Appendix B: Existing and Proposed Development Drawings

Saville Theatre

EWP Mark-Up

Mark-Up Title: Pile Loads

Drawing Title
Proposed Ground Floor Plan

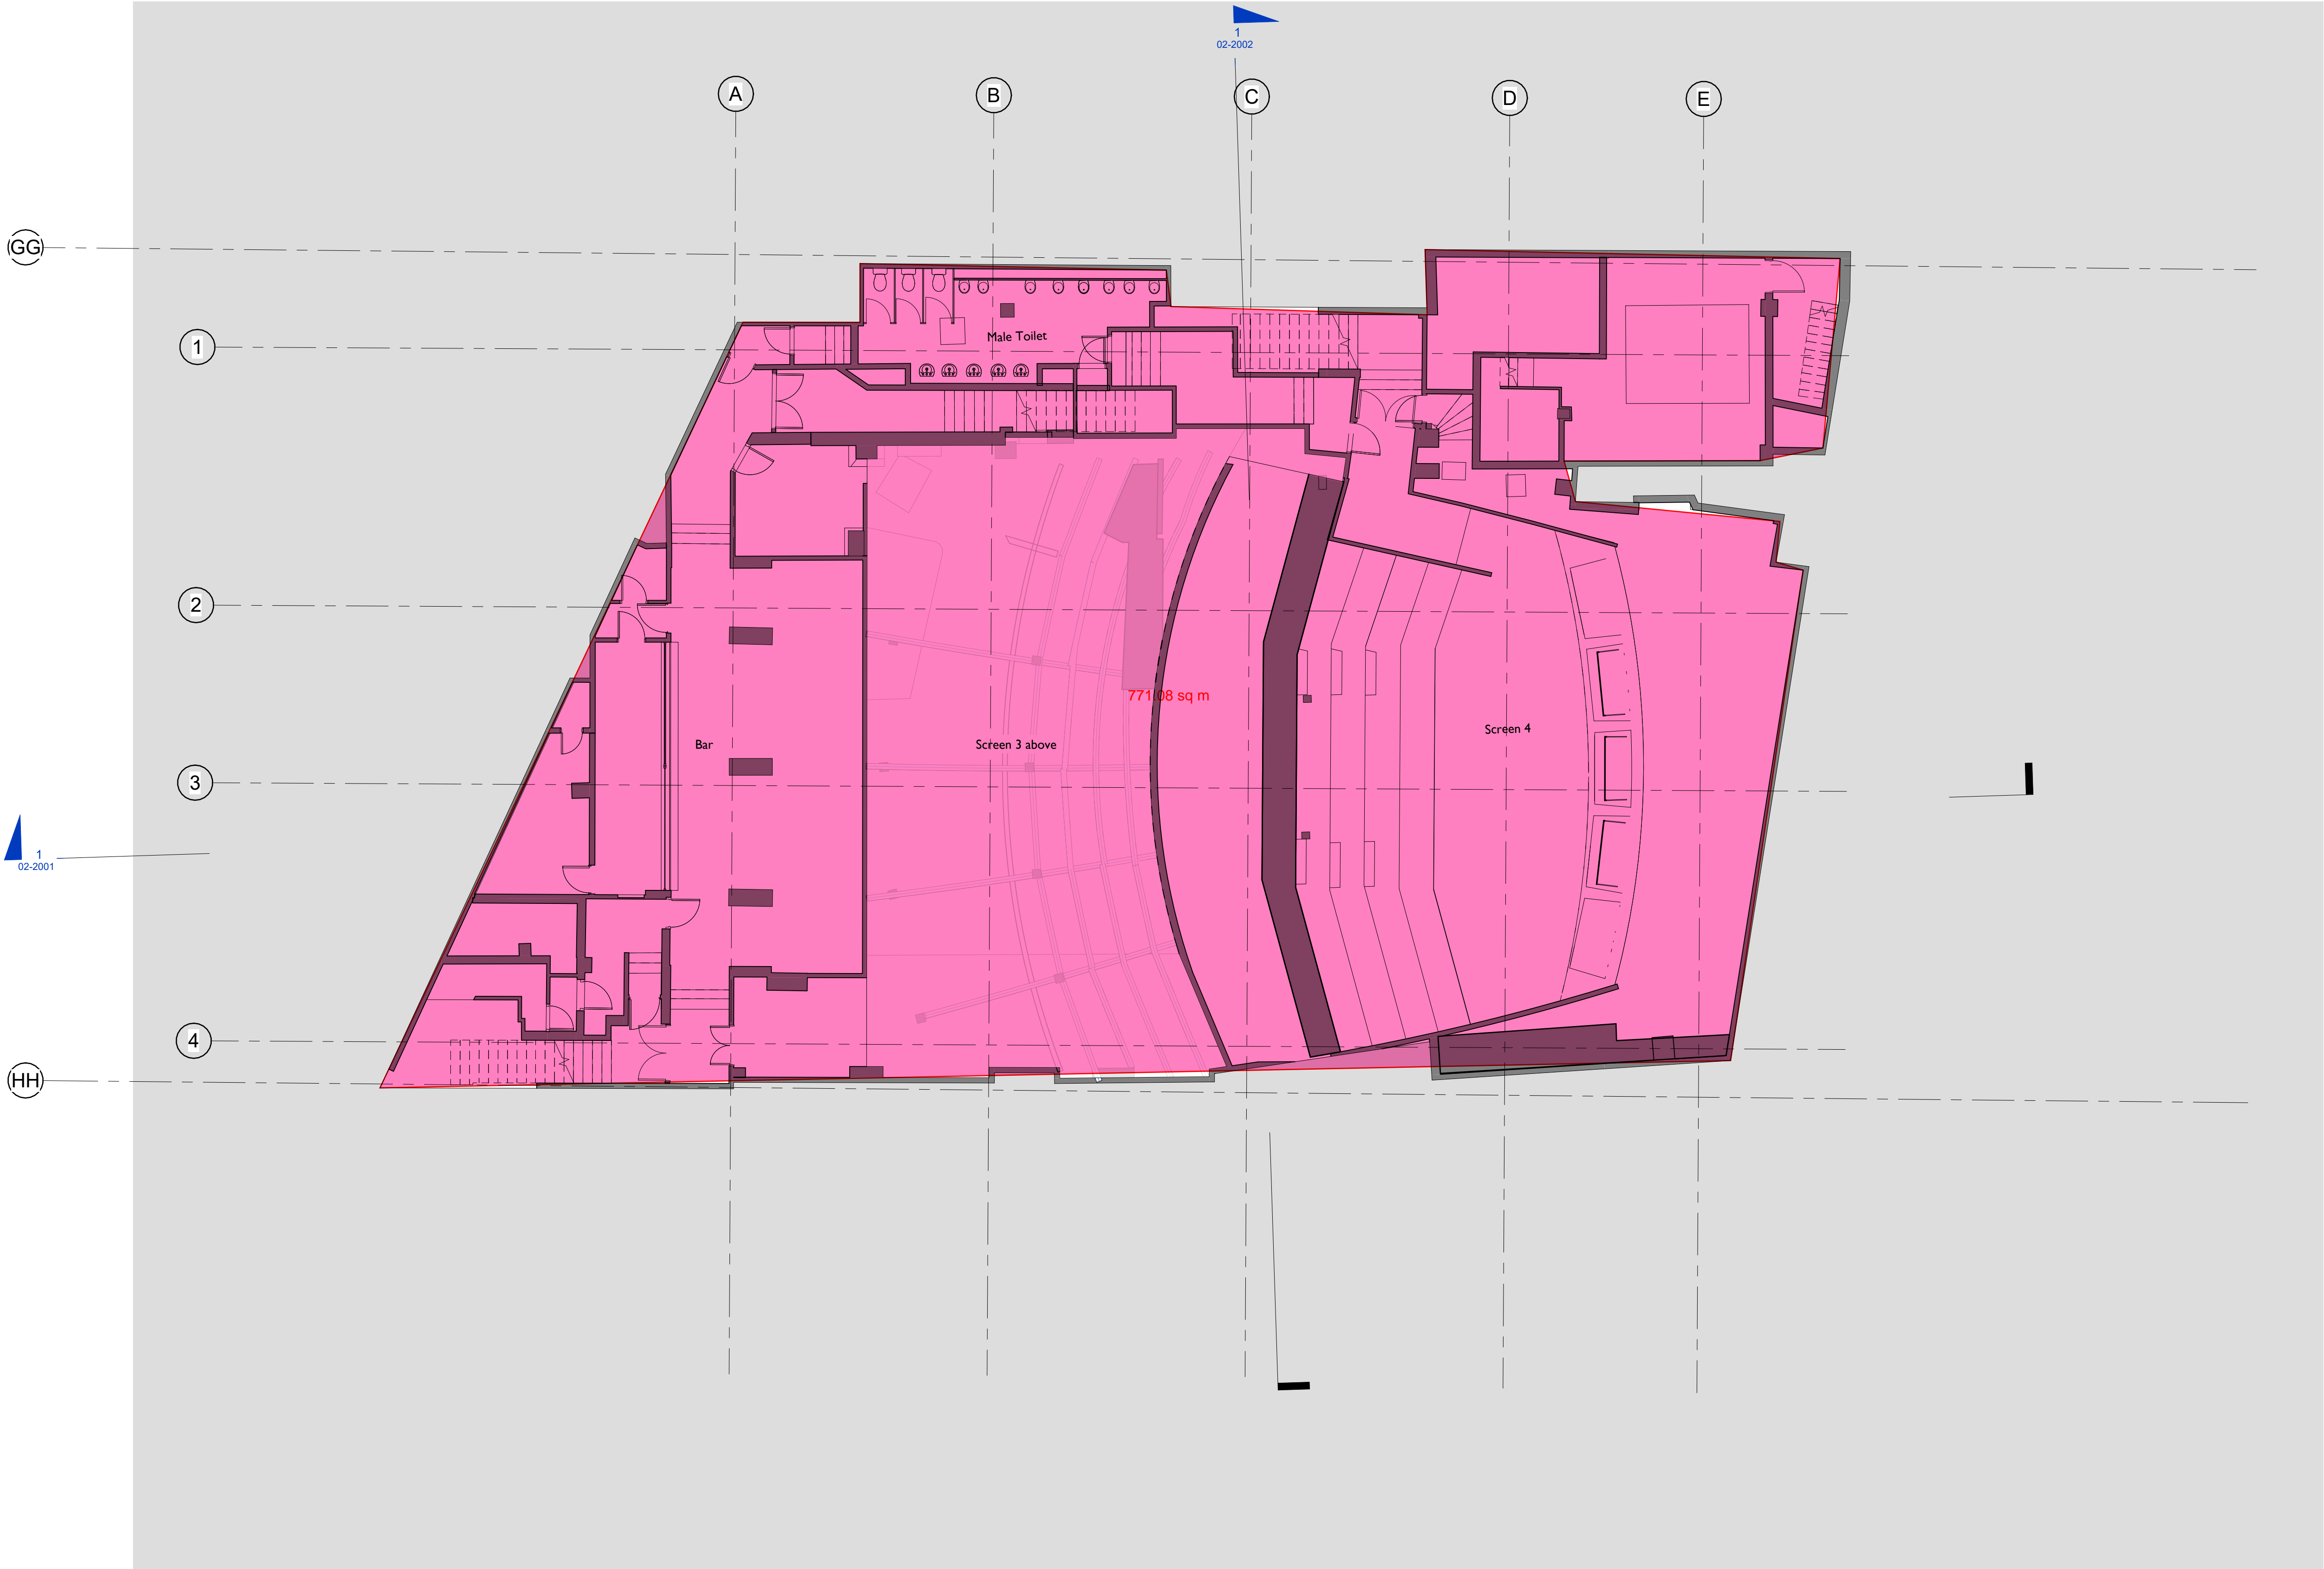
ADD NOTE: ALLOW FOR 2m x2.5m DEEP CAPPING BEAM TO PERIMETER, CAPPING BEAM TO BE LOCALLY EXTENDED APPROPRIATELY, WHERE THICKER LINING WALLS PROPOSED.

STAIR OPENING SIZE TO BE REVIEWED. ALLOWANCE TO BE MADE FOR THICKER LINING WALL AND REQUIREMENT FOR SLAB AS SHOWN

RETAINING WALL STRATEGY AT LOCATIONS WHERE RETAINED FACADE IS PRESENT ABOVE TO BE AGREED WITH CONTRACTOR. LIKELY CONSTRUCTED IN UNDERPINS

EXISTING RETAINED FACADE ALONG SHAFTESBURY AVENUE. ALLOW FOR NEW STRUCTURE INSTALLED IN SEQUENCE (SUCH AS PYNFORD BEAM) TO SUPPORT FACADE AT GROUND FLOOR LEVEL. INTERFACE TO BE CONFIRMED FOLLOWING SITE INVESTIGATIONS AND AGREEMENT OF BASEMENT CONSTRUCTION SEQUENCE .

STRUCTURE FROM GF AND ABOVE IS IN ABEYANCE. ALLOW FOR ADDITIONAL BEAMS BETWEEN TRANSFER TRUSSES SHOWN TO SUPPORT SUPERSTRUCTURE COLUMNS. FINAL POSITION OF TRUSSES TO BE COORDINATED ONCE SUPERSTRUCTURE LAYOUTS ARE FINALISED
